# PRIVATE WATER DISTRIBUTION SYSTEM

## FOLEY EQUIPMENT 1300 S. WEST STREET CITY OF WICHITA, KANSAS

1990 PPW (607853) - Water Line 1, Fire Line E,

AS BUILT PLANS  
CONTRACTOR: PEARSON CONSTRUCTION  
INSPECTOR: LEVI TURNER,  
RUGGLES & BOHM  
PDF BY: LCT 09/19/2017

**WATER MAIN LOWERING DETAILS**

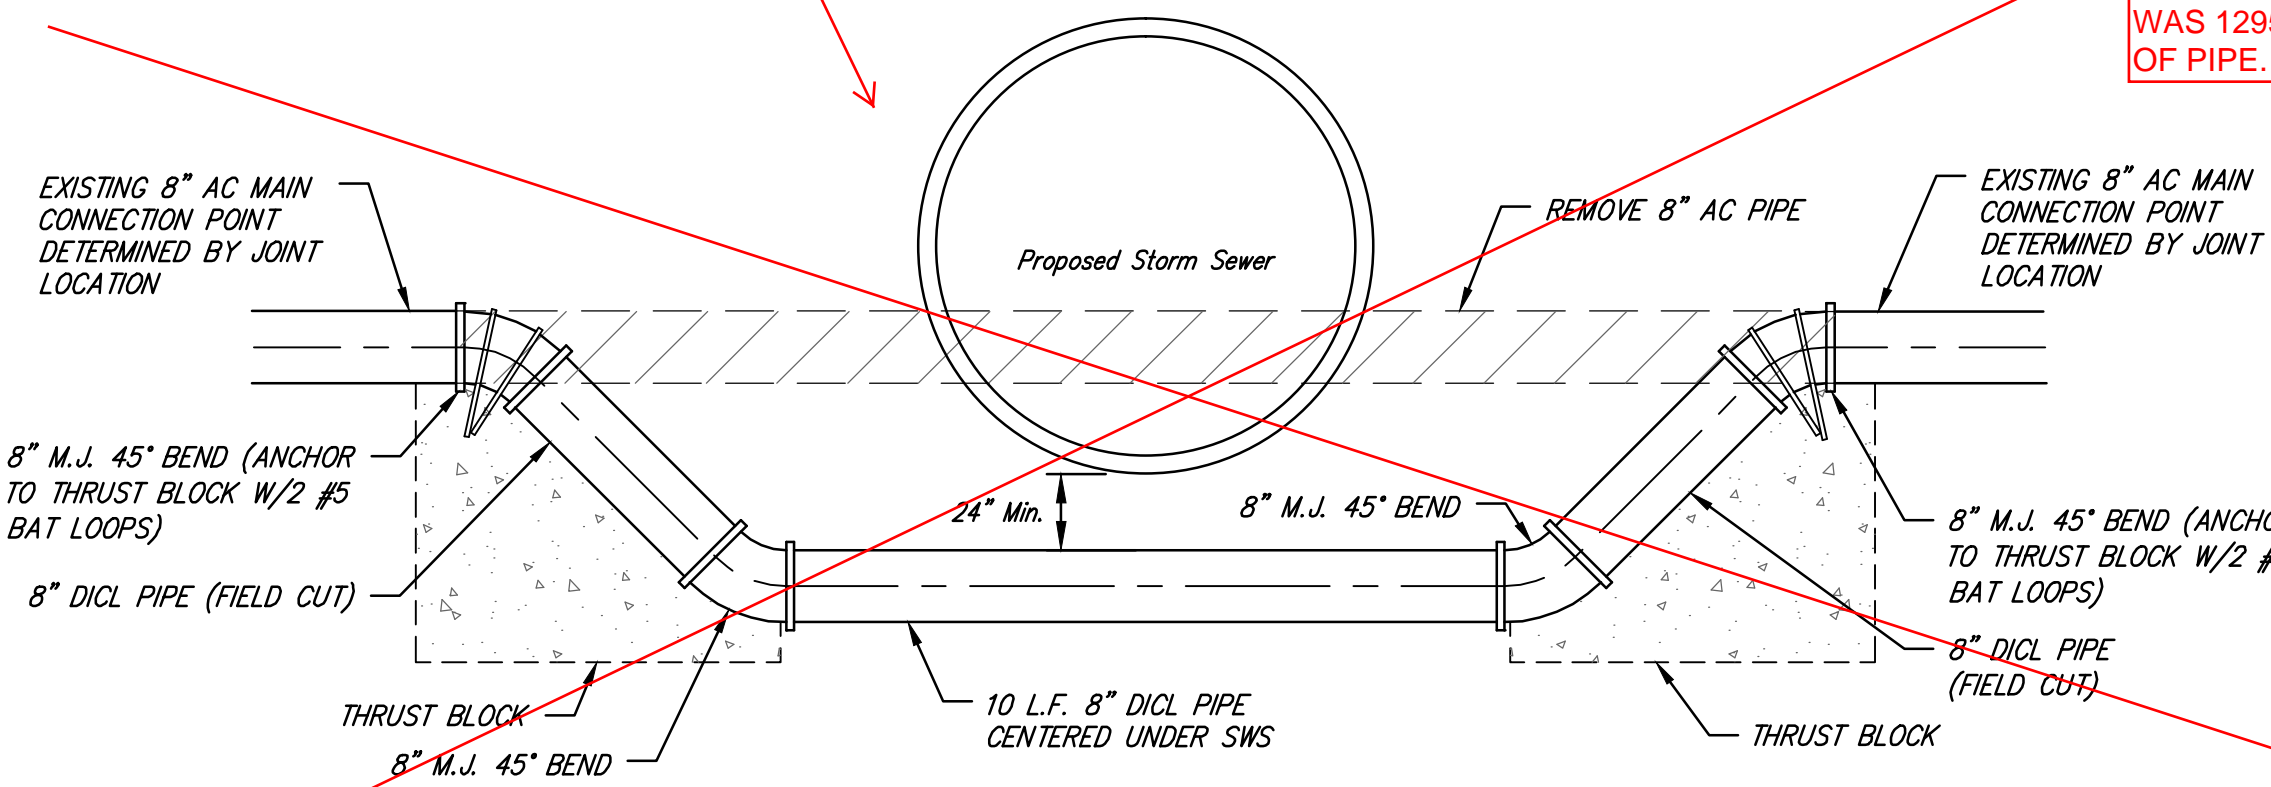
THIS WORK WASN'T REQUIRED

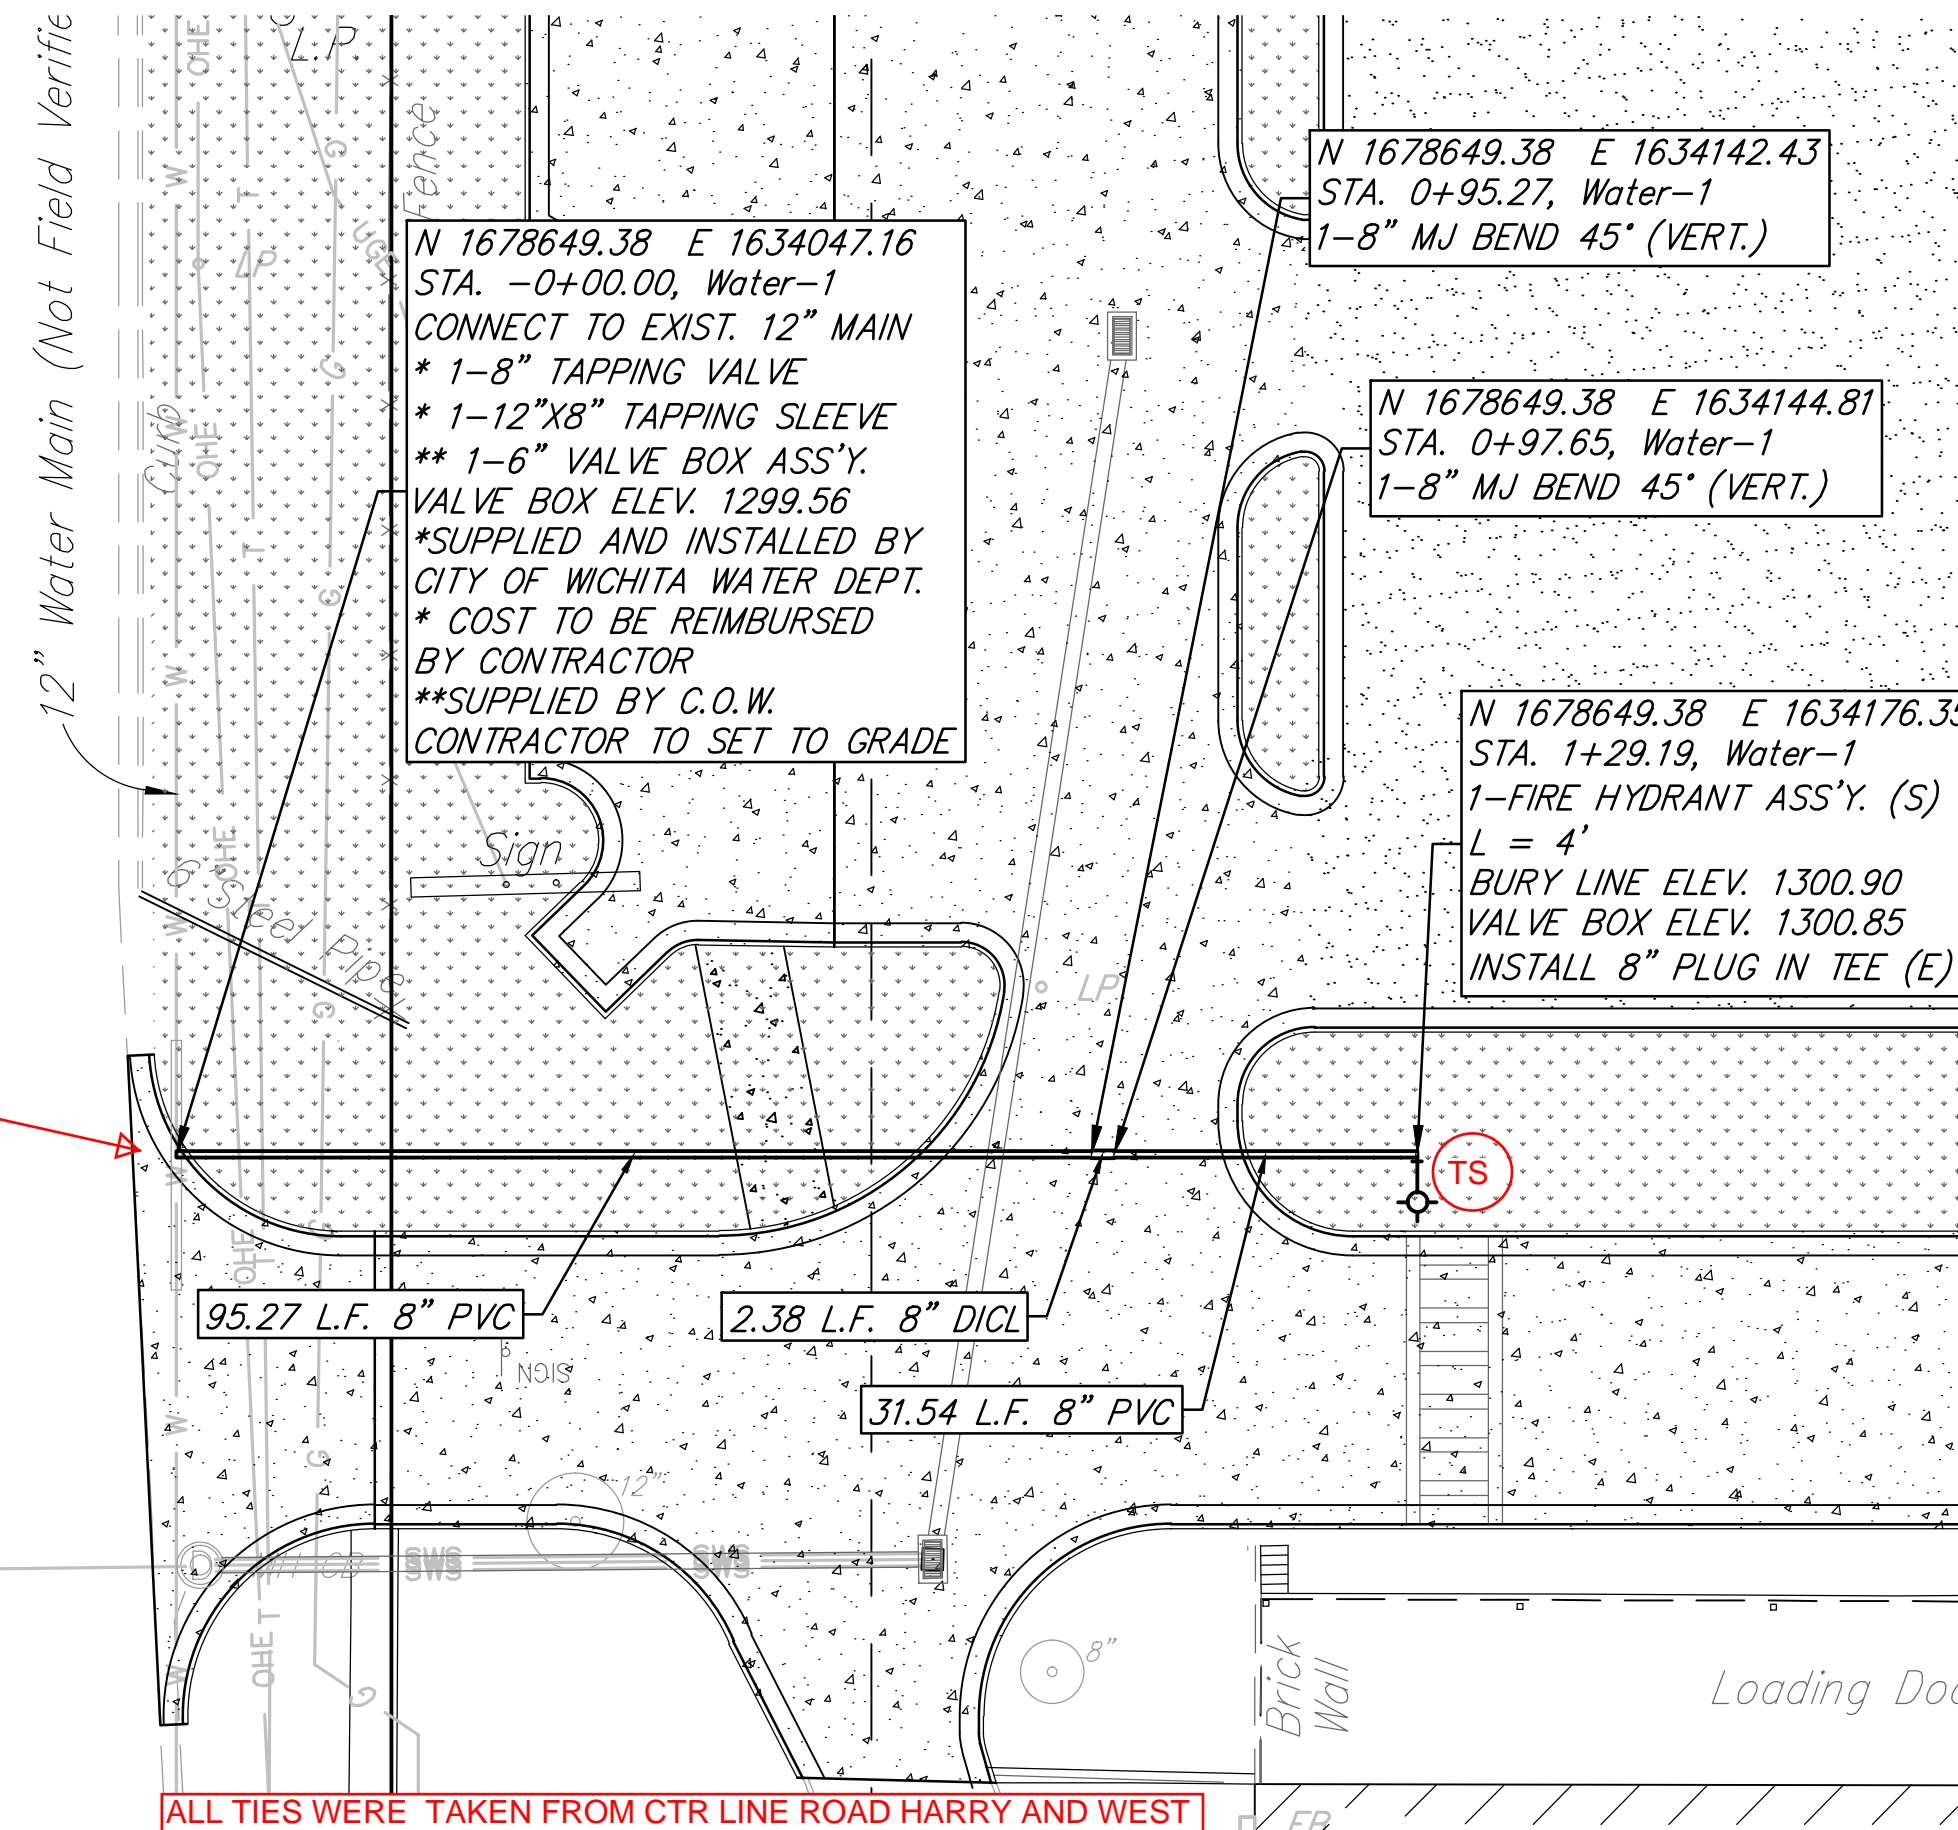
ALL TIES WERE TAKEN FROM CTR LINE ROAD HARRY AND WEST  
 417.57' N, 27.63' E - TAP  
 417.57' N, 29.63' E - VALVE BOX  
 417.57' N, 122.90' E - 45 DEG VERTICAL BEND  
 417.57' N, 125.28' E - 45 DEG VERTICAL BEND  
 417.57' N, 156.82' E - 90 DEG HORIZONTAL BEND  
 416.57' N, 156.82' E - VALVE BOX  
 412.57' N, 156.82' E - FIRE HYDRANT
